**Co3265 – Pittsford-Brandon NH 019-3(494)**

**ADDENDUM #4**

Plan Sheets 30, 31, 32, 33, 36, 37, 226, 238, 256, 265, 270, 429, 432 & 433 have been revised.

PROJECT NAME:	PITTSFORD-BRANDON
PROJECT NUMBER:	NH 019-3(494)
FILE NAME:	z02b198box_110.dgn
PROJECT LEADER:	P. SHEDD
DESIGNED BY:	R. TRUDEAU
BOX CULVERT TCP PHASE 1A TYPICAL BR 110 SHEET	238 OF 529
PLOT DATE:	4/10/2026
DRAWN BY:	M. SMITH
CHECKED BY:	S. BEAUMONT

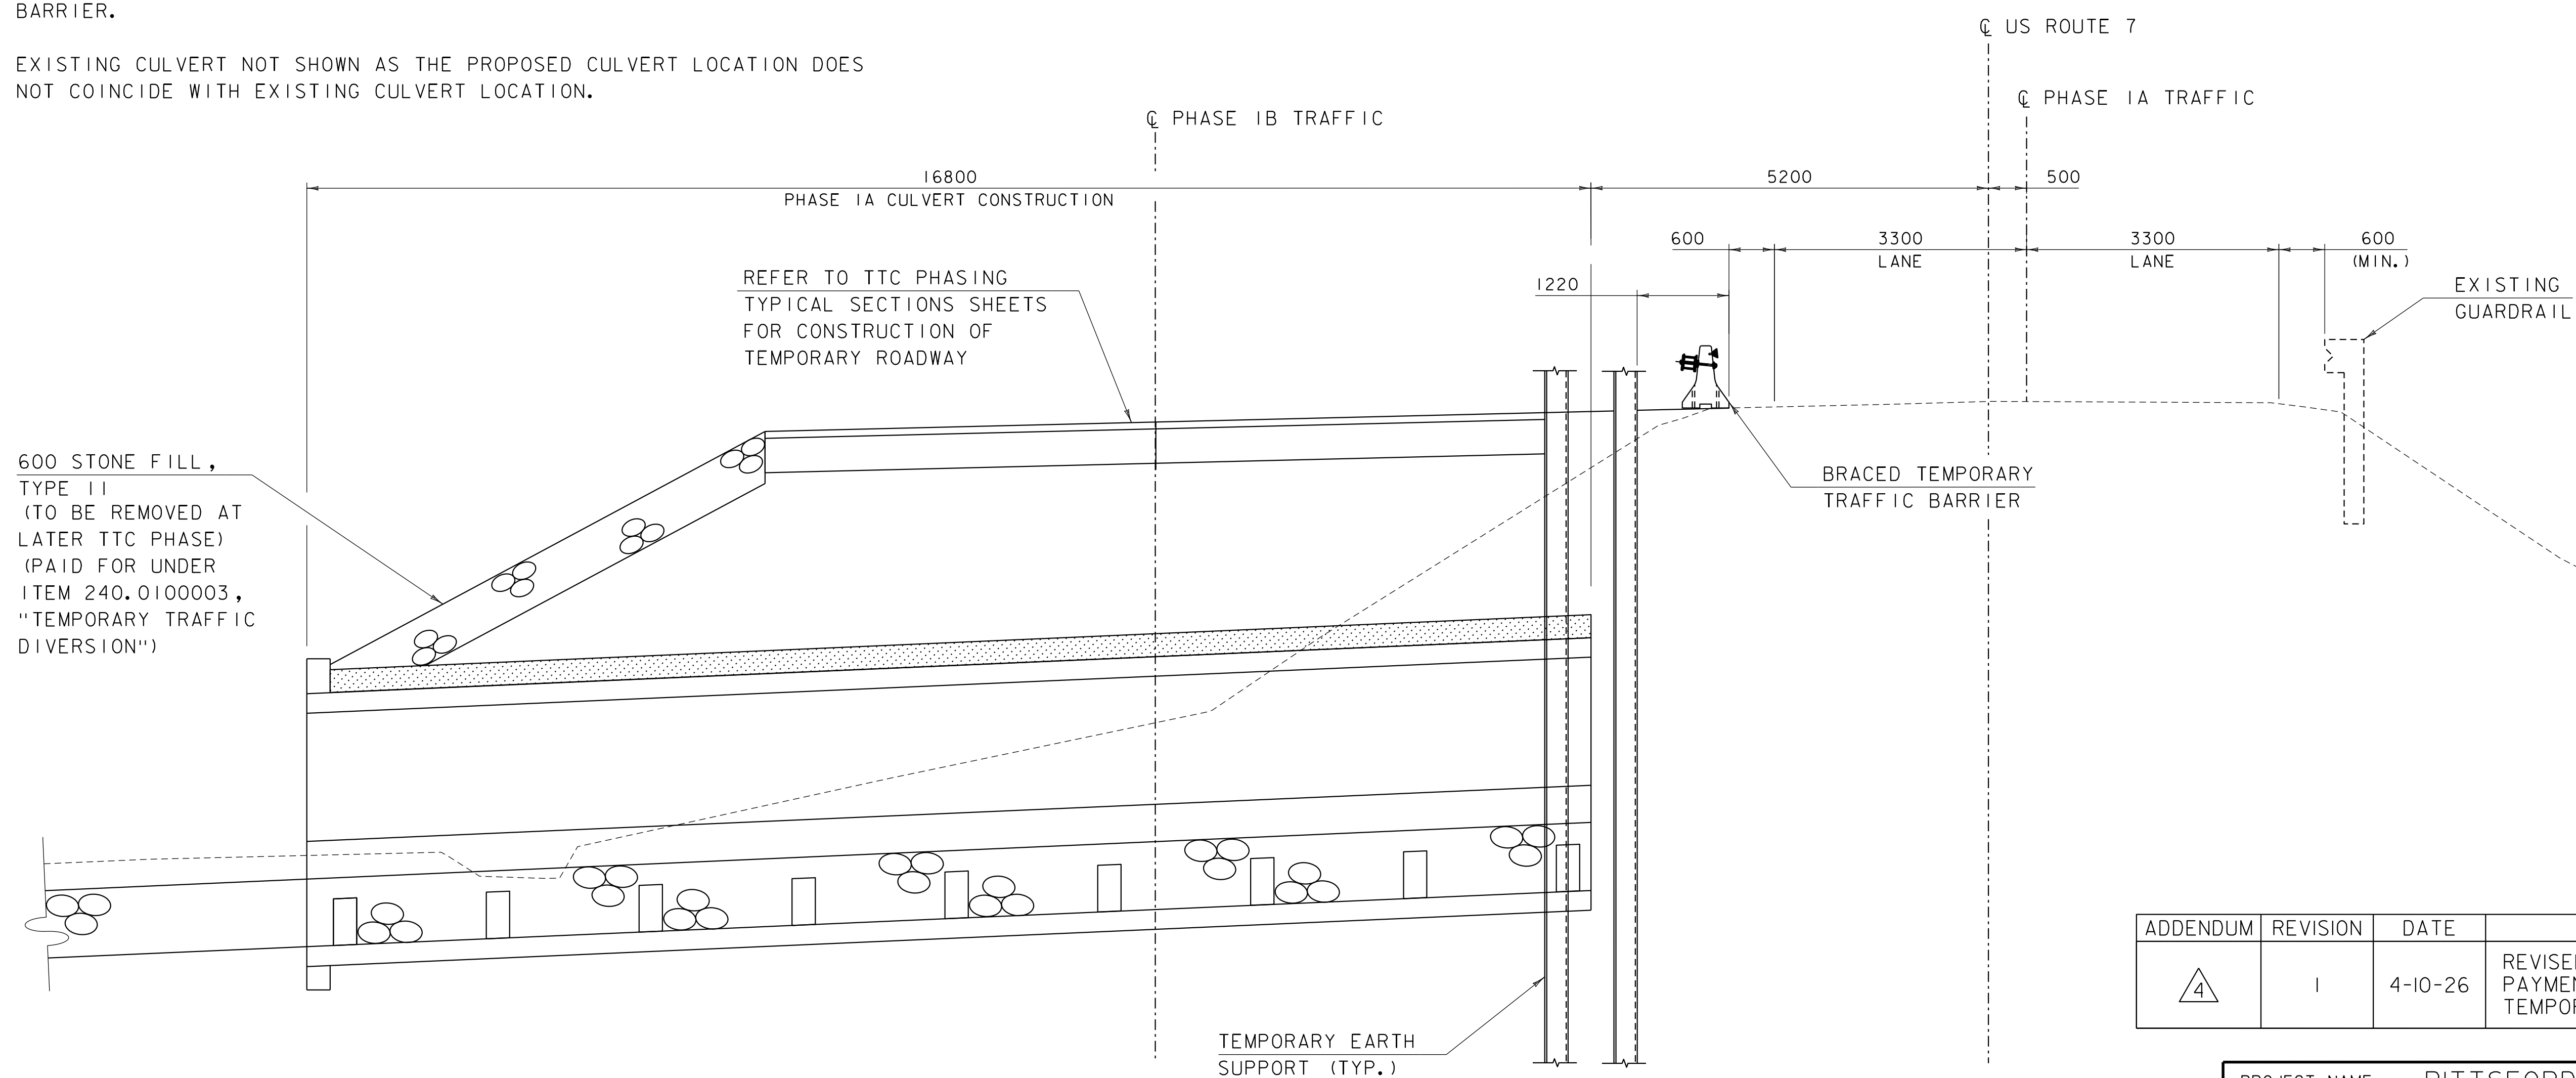
3. ~~TEMPORARY TRAFFIC BARRIER WILL BE PAID FOR UNDER ITEM 621.2400, "TEMPORARY TRAFFIC BARRIER". REMOVING AND RESETTING TEMPORARY TRAFFIC BARRIER WILL BE PAID FOR UNDER ITEM 621.0200, "REMOVE AND RESET TEMPORARY TRAFFIC BARRIER".~~  
 TEMPORARY TRAFFIC BARRIER AND REMOVING AND RESETTING TRAFFIC BARRIER WILL BE CONSIDERED INCIDENTAL TO ITEM 240.0100003, "TEMPORARY TRAFFIC DIVERSION".

ADDENDUM	REVISION	DATE	DESCRIPTION	BY
4	1	4-10-26	REVISED NOTE REGARDING PAYMENT FOR TEMPORARY BARRIER	SRB

PROJECT NAME: PITTSFORD-BRANDON  
 PROJECT NUMBER: NH 019-3(494)  
 FILE NAME: z02b198box\_III.dgn  
 PROJECT LEADER: P. SHEDD  
 DESIGNED BY: R. TRUDEAU  
 PLOT DATE: 4/10/2026  
 DRAWN BY: M. SMITH  
 CHECKED BY: S. BEAUMONT  
 PHASE 2 AND 3 CONSTRUCTION SHEET BR 111 SHEET 256 OF 529

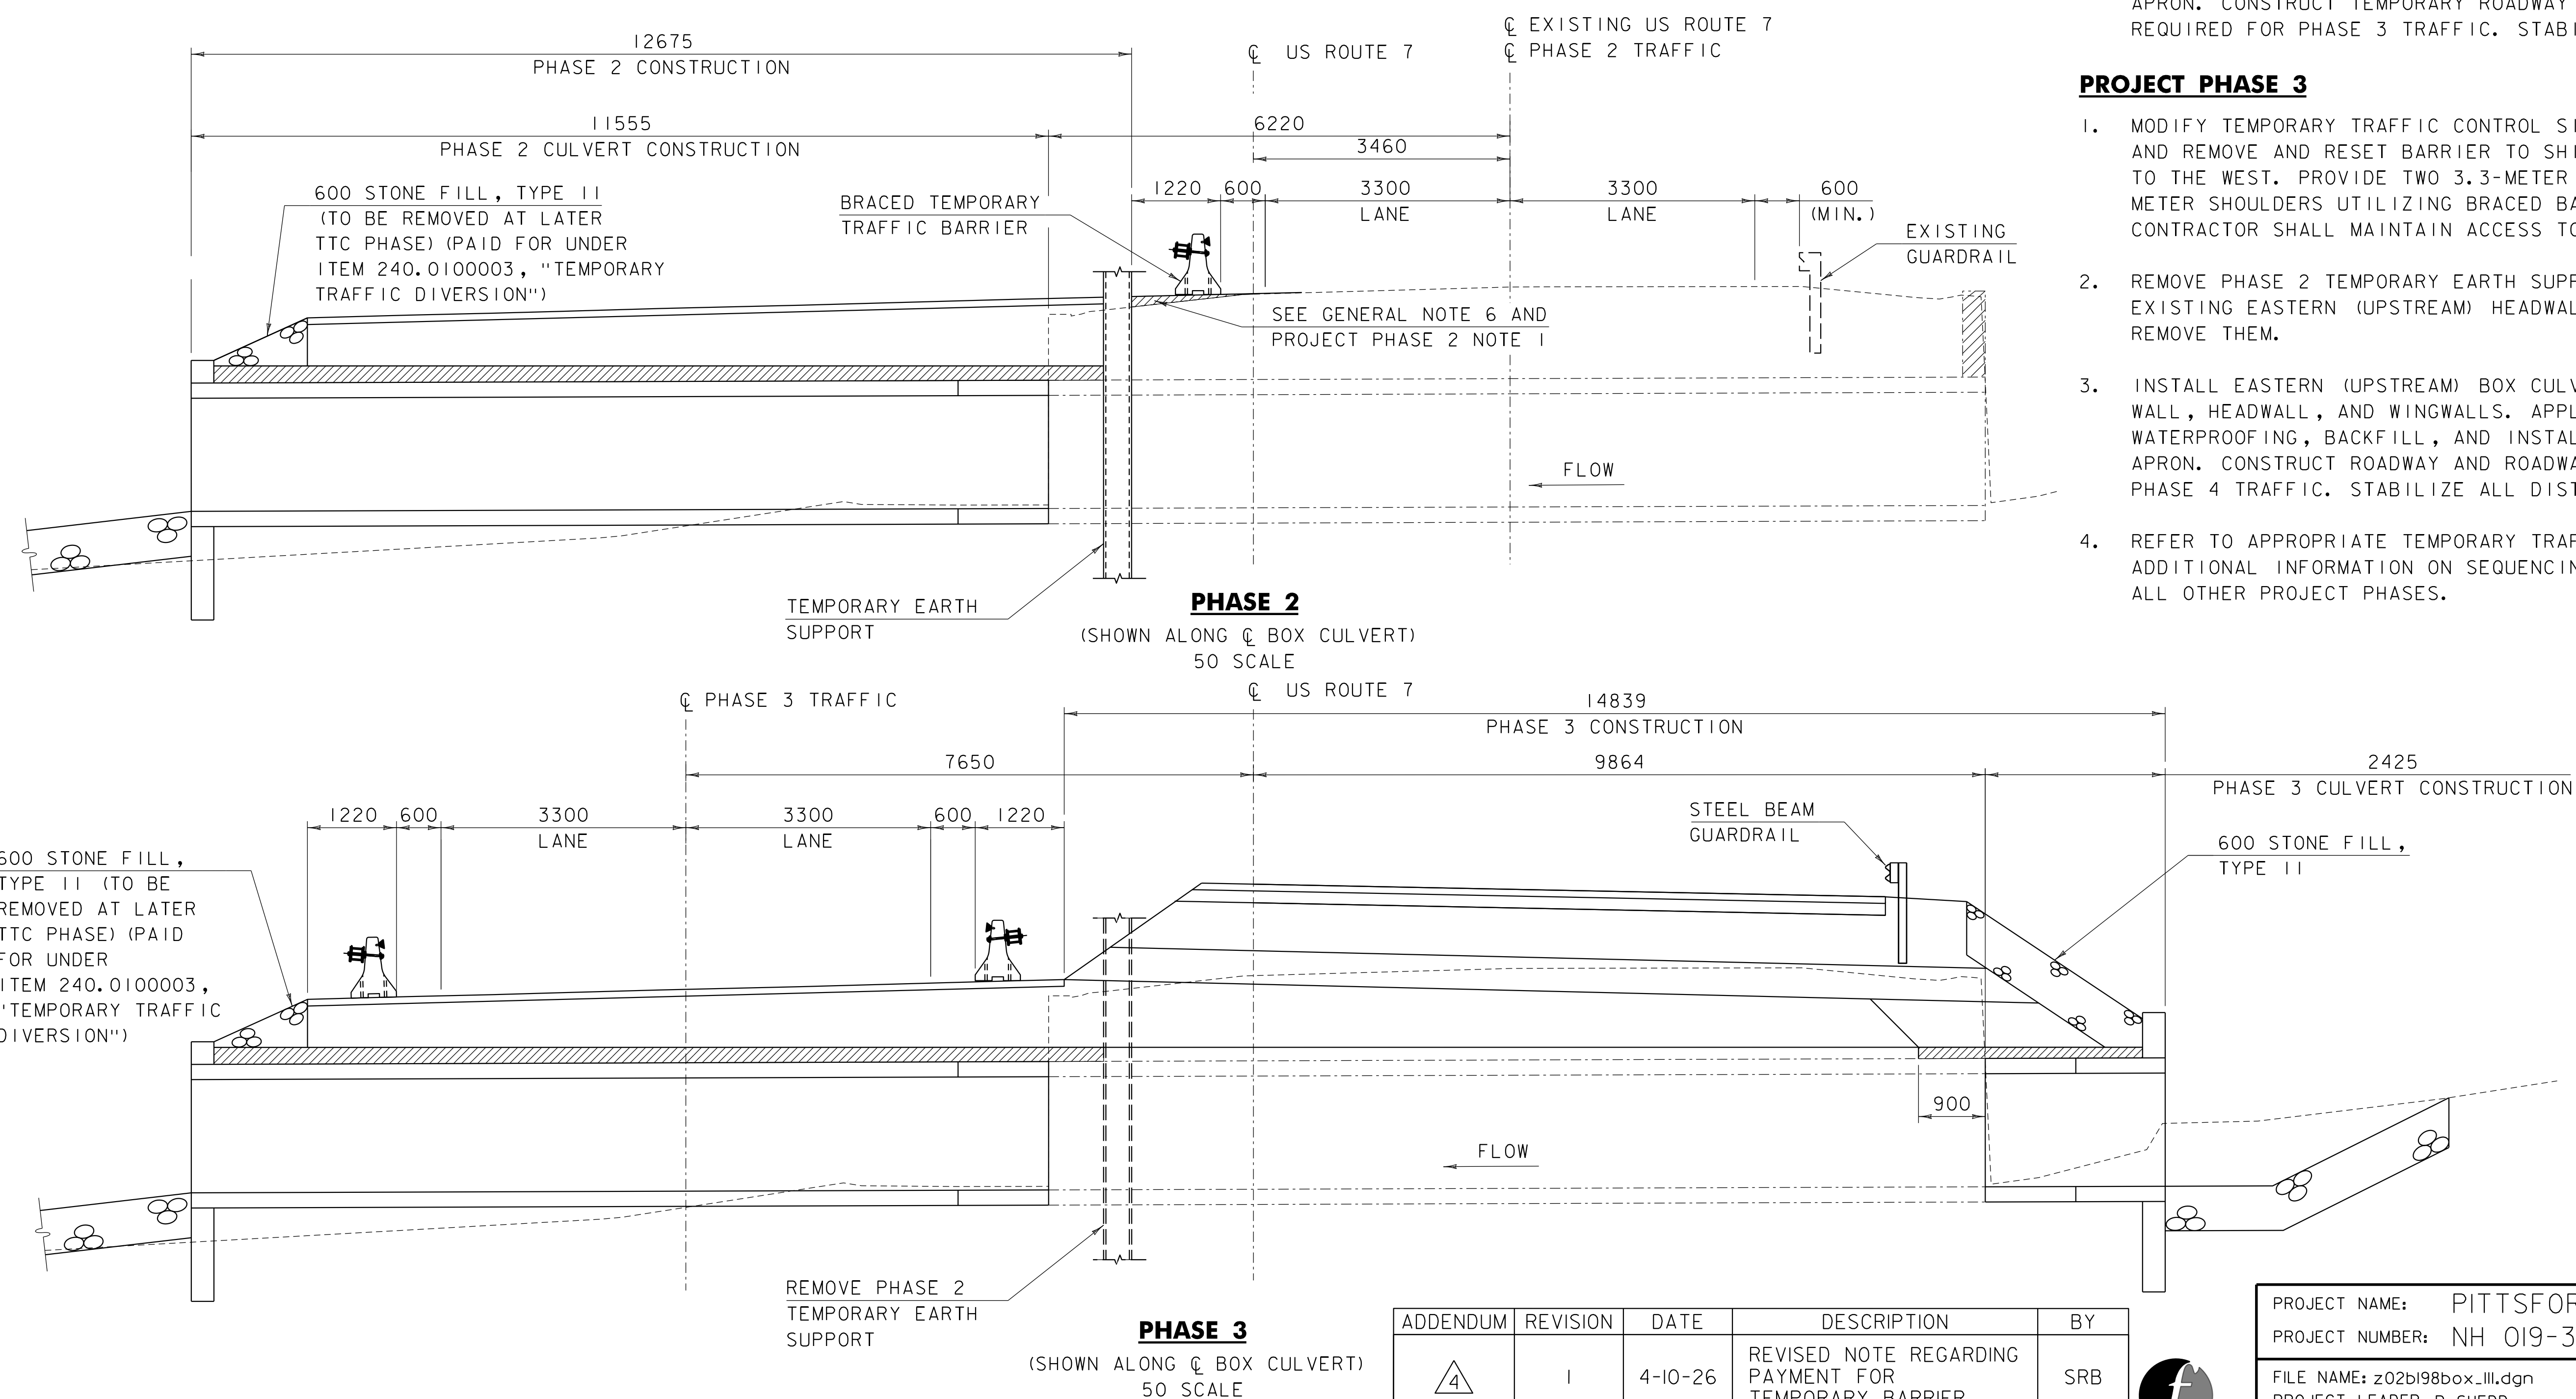
~~3. TEMPORARY TRAFFIC BARRIER WILL BE PAID FOR UNDER ITEM 621.2400, "TEMPORARY TRAFFIC BARRIER". REMOVE AND RESETTING TEMPORARY TRAFFIC BARRIER WILL BE PAID FOR UNDER ITEM 621.0200, "REMOVE AND RESET TEMPORARY TRAFFIC BARRIER".~~

TEMPORARY TRAFFIC BARRIER AND REMOVING AND RESETTING TRAFFIC BARRIER WILL CONSIDERED INCIDENTAL TO ITEM 240.0100003, "TEMPORARY TRAFFIC DIVERSION"

ADDENDUM	REVISION	DATE	DESCRIPTION	BY
A	1	4-10-26	REVISED NOTE REGARDING PAYMENT FOR TEMPORARY BARRIER	SRB
